HEARING IN THE MATTER OF
CALIFORNIA DEPARTMENT OF
WATER RESOURCES AND UNITED
STATES BUREAU OF
RECLAMATION
REQUEST FOR A CHANGE IN POINT
OF DIVERSION FOR CALIFORNIA
WATER FIX

SURREBUTTAL TESTIMONY OF
DEIRDRE DES JARDINS

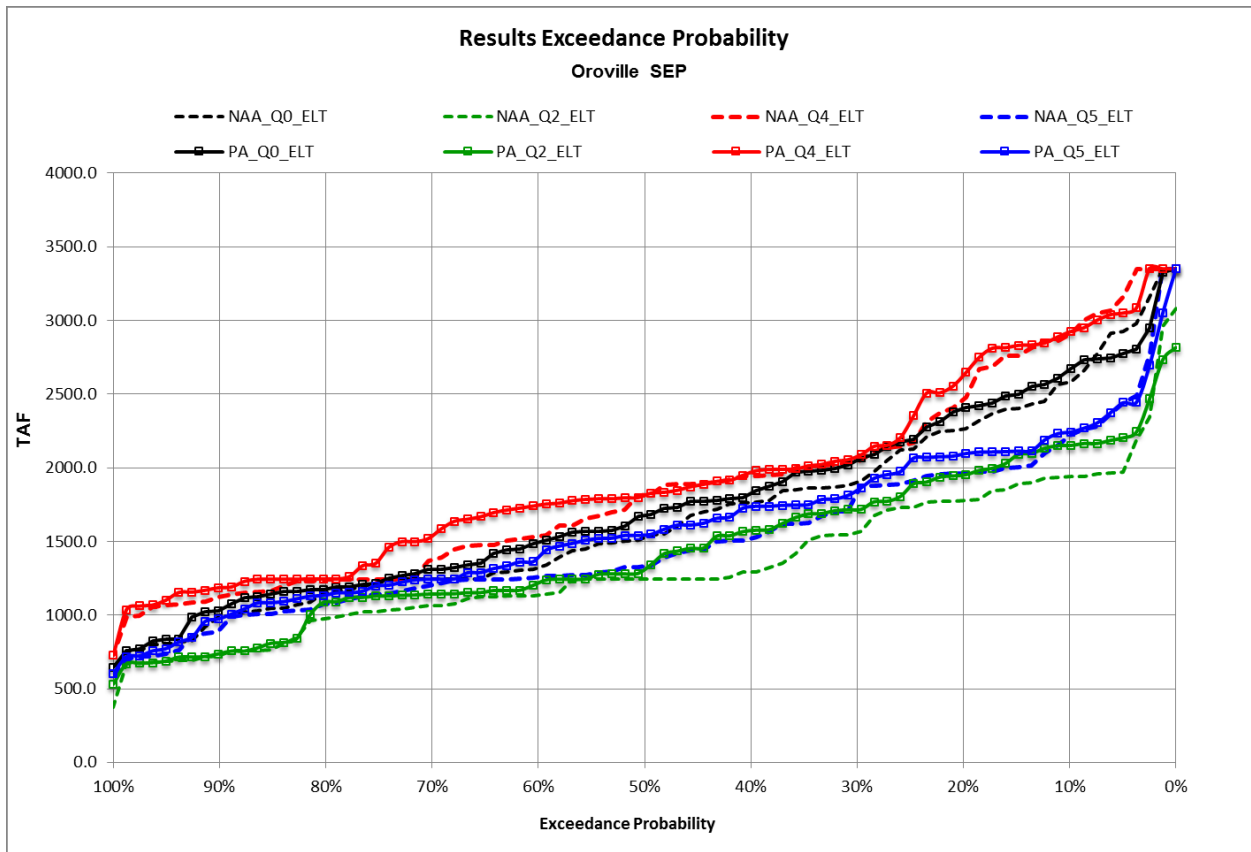
Mr. Leahigh testified that the “floor” was increased to 1.3 million acre feet, but this may still not be enough, given that the 2013 End of September carryover storage was about 1.6 million acre-feet.

Mr. Leahigh testified that the “floor” was changed to 1.3 million acre feet.

Estimated Relative Sea Level Change Projections From 2000 To 2135 -
Gauge: 9415144, Port Chicago, CA (2,79 mm/yr)

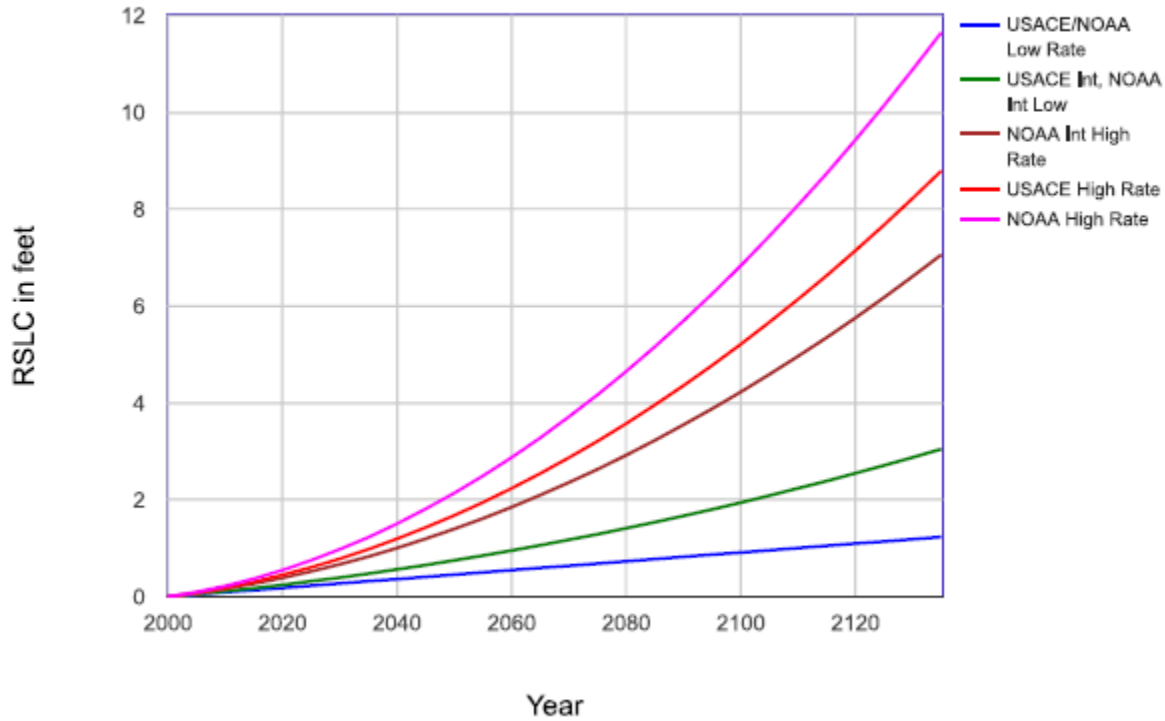
5
6 The closest NOAA tide gauge to the Delta is at Port Chicago. The USACE low, intermediate,
7 and high scenarios at the NOAA tide gauge at Port Chicago were provided in testimony in Part 1B for
8 Pacific Coast Federation of Fishermens' Associations / Institute for Fisheries Resources (PCFFA/IFR.)
9 as a graph in exhibit PCFFA-65 and a table in exhibit PCFFA-64.

10 The curves in exhibit PCFFA-65 were provided through 2135, which was the end of the
11 estimated 100 year lifetime of the project, and within the lifetime of the Change Petition. The USACE
12 intermediate and high rates of sea level rise are somewhat lower than those estimated by NOAA, but
13 similar.
